Department of Environmental Protection

RE: Lena Road Landfill, Permit No. : SO41-211176, Manatee County
Financial Assurance Cost Estimates

Re Lena Road Landfill Stage III Gradient, Corrective Actions
Permit No.: SO41-211176, Manatee County

SUBJECT: weir STAGE III

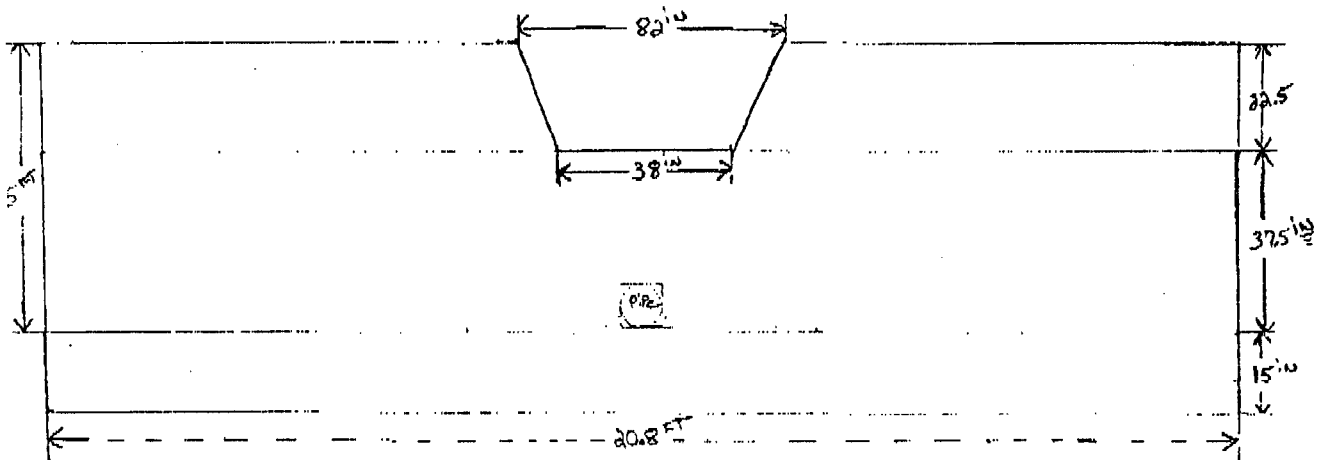
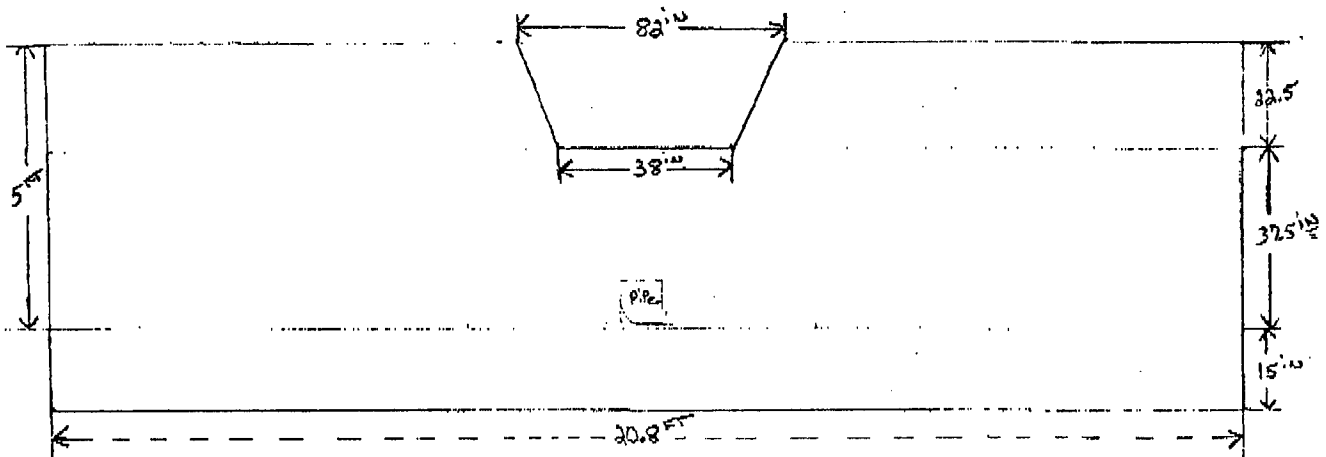
FOOTER ELAV.
1.5' IN BELOW
FLOW LINE
OF OUT FALL
PIPE.

15' IN FOOTER

11 1/2" IN WIDE

20.8 FT LONG

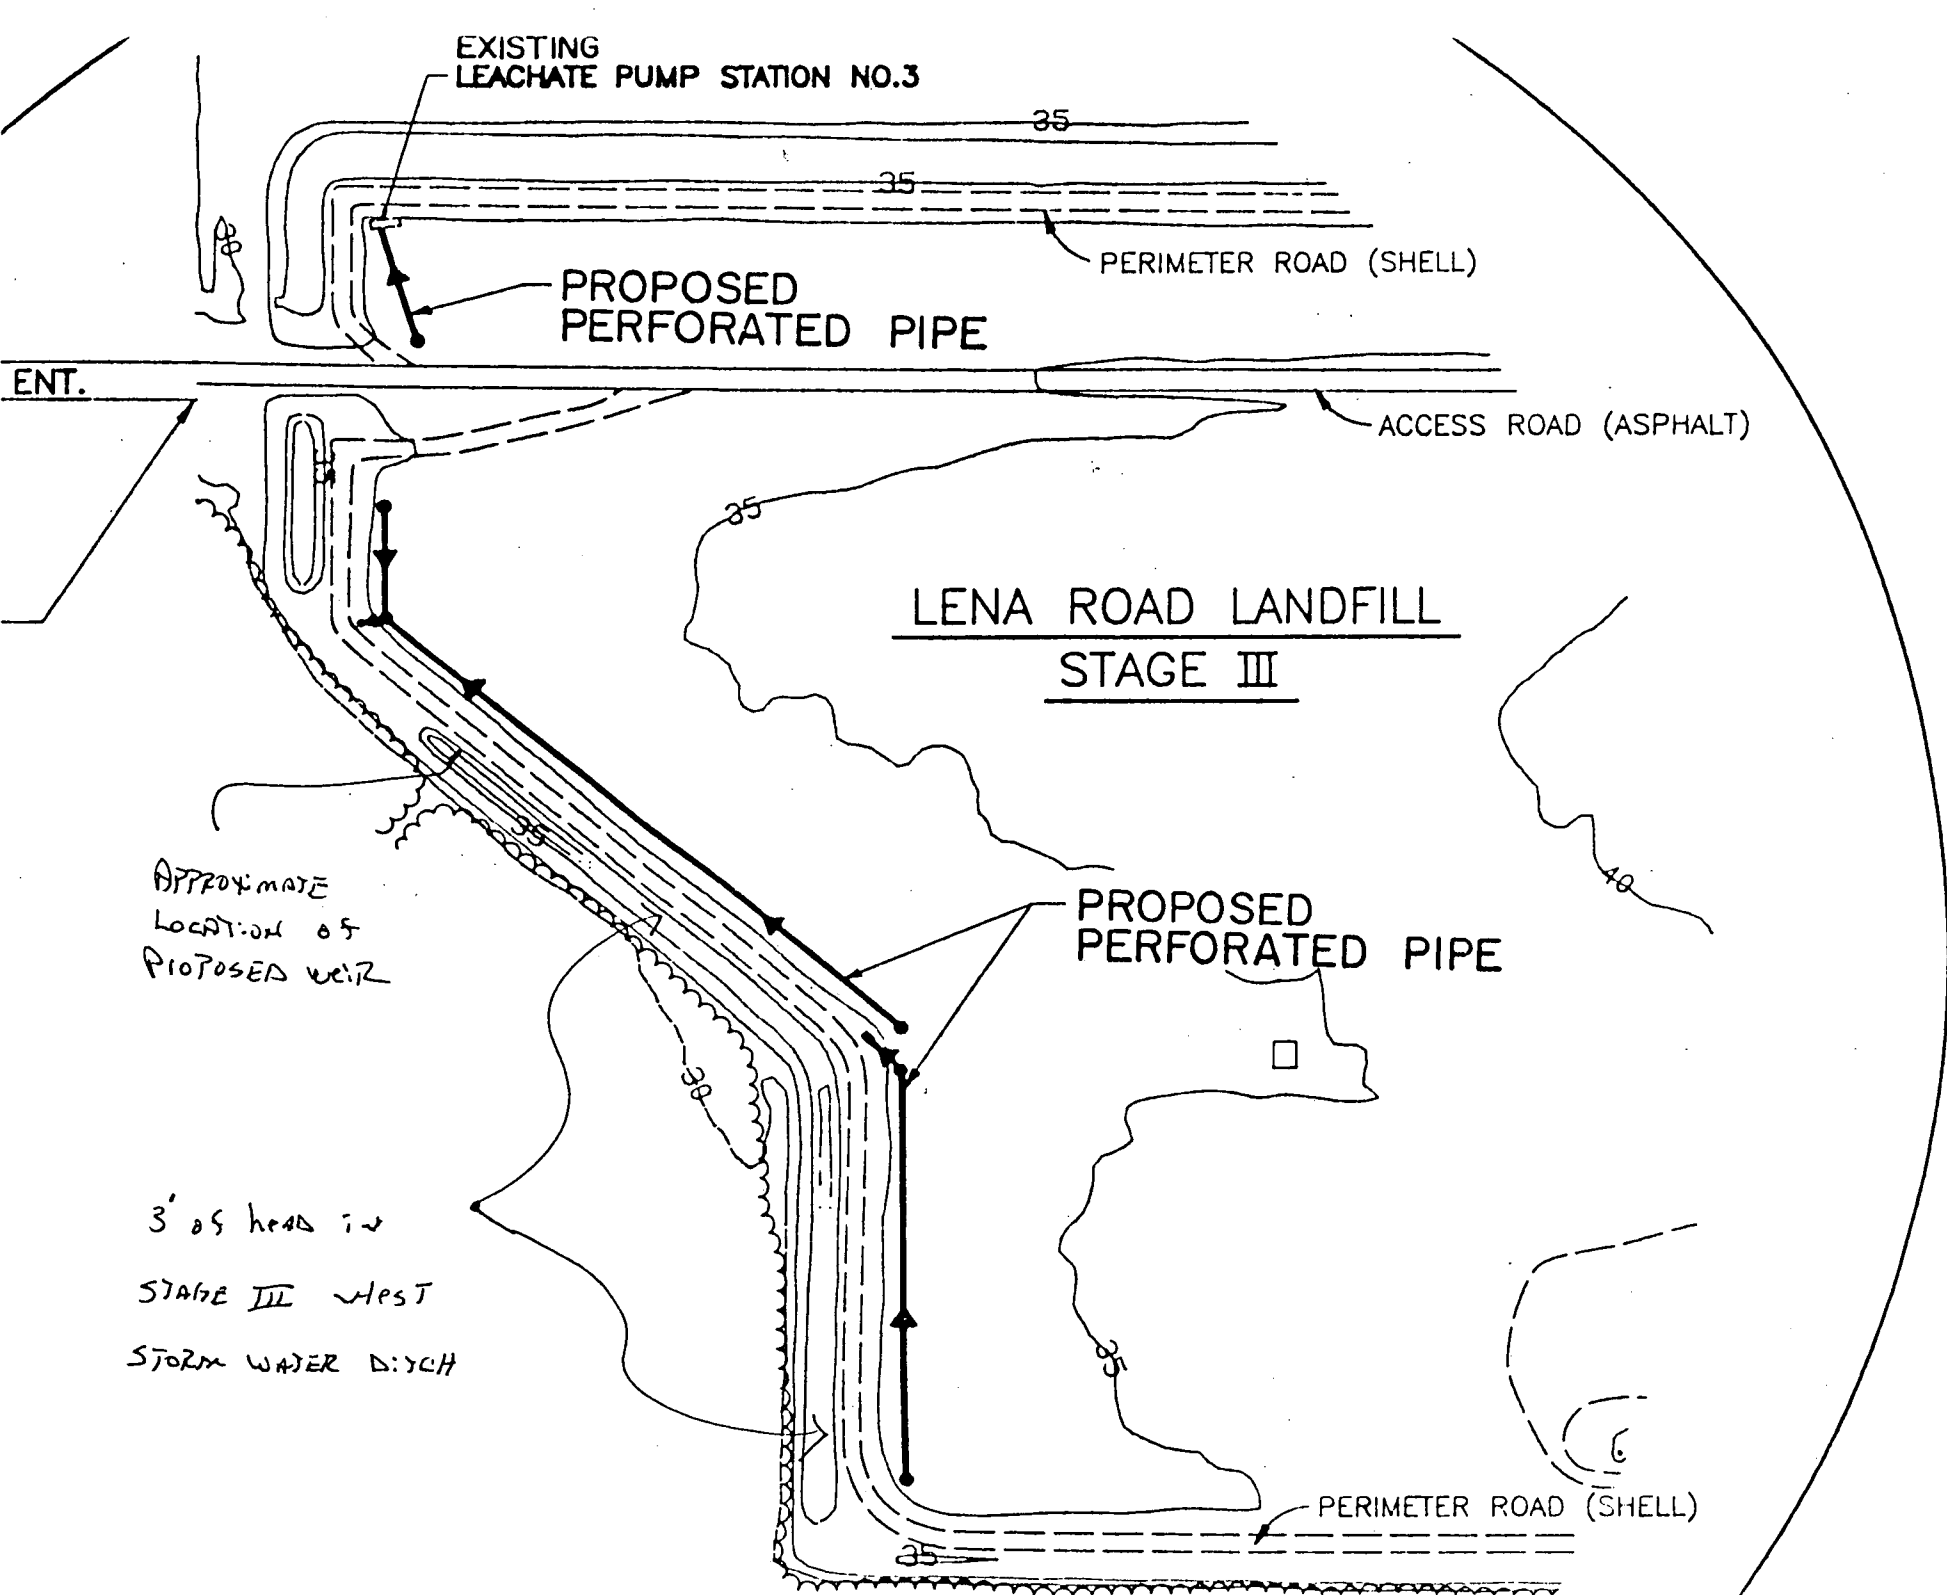
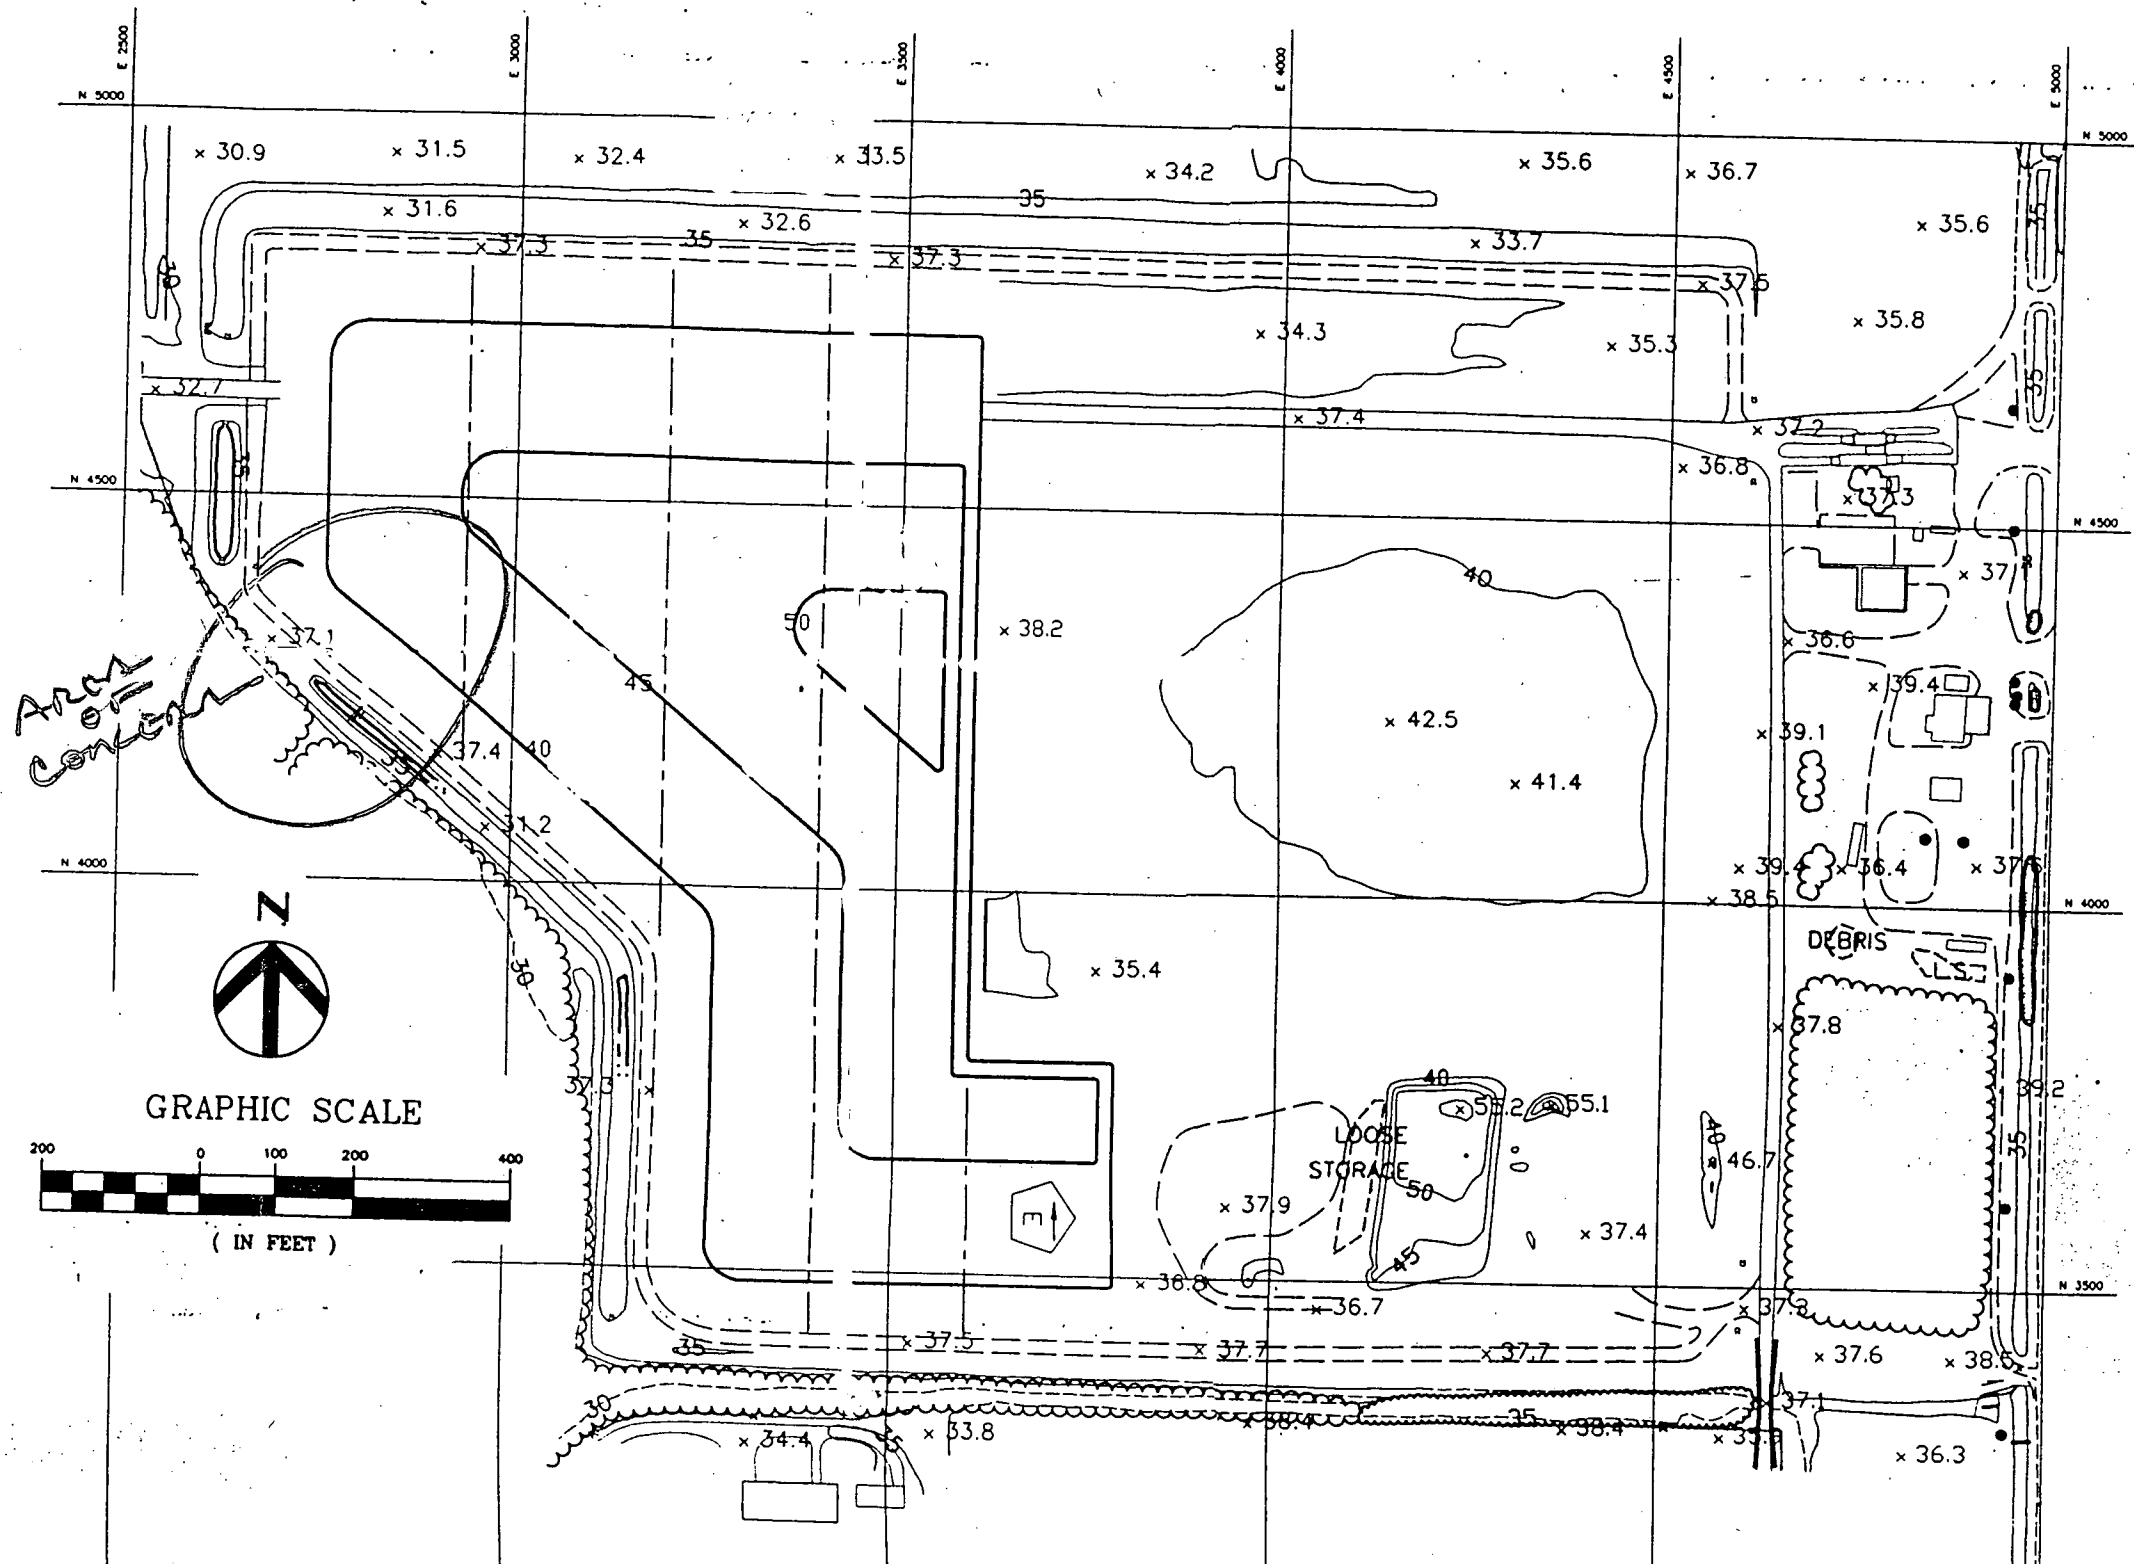
As discussed with you and verified with historical data, an outward gradient exist on the western side of Stage III, specifically at PZ-15. Refer to the attached map for details. In an attempt to reverse the gradient staff proposes the following:

- Construct a weir in the west storm water ditch of Stage III, at the location indicated on the map. The weir will allow storm water to backup along the entire west storm water ditch. The overflow for the weir will be approximately 3 feet above the ditch bottom.
- Once the weir is constructed, storm water from the storm water pond will be pumped into the ditch. A maximum head of 3 feet will be maintained in the ditch. As discussed, an inward gradient should result along the west side of Stage III if sufficient head is maintained in the ditch.

Staff proposes this change to the storm water system be temporary, only to determine if an inward gradient can be maintained. If an inward gradient is maintained, staff suggests the change become permanent and part of our storm water management system until a new design is implemented. If you require further information, or need assistance regarding this matter, please contact me at (941) 748-5543.

The Department has no objections to the corrective actions concerning the installation of a weir, ditch block or inlet type structure, in the Stage III stormwater conveyance swale and stormwater pumping (if necessary) as proposed in your September 12, 1997 letter subject to the following condition:

- Pumping of stormwater into the swale shall be controlled to maximize recharge in the swale, and to prevent the overflow and subsequent discharge of pumped stormwater from the swale.

The proposed activities are considered experimental and will serve as a demonstration to be used as the basis of approval as part of the permit application for landfill operation and maintenance. Therefore, a permit modification is not required. The Department appreciates all efforts being made to resolve this matter.
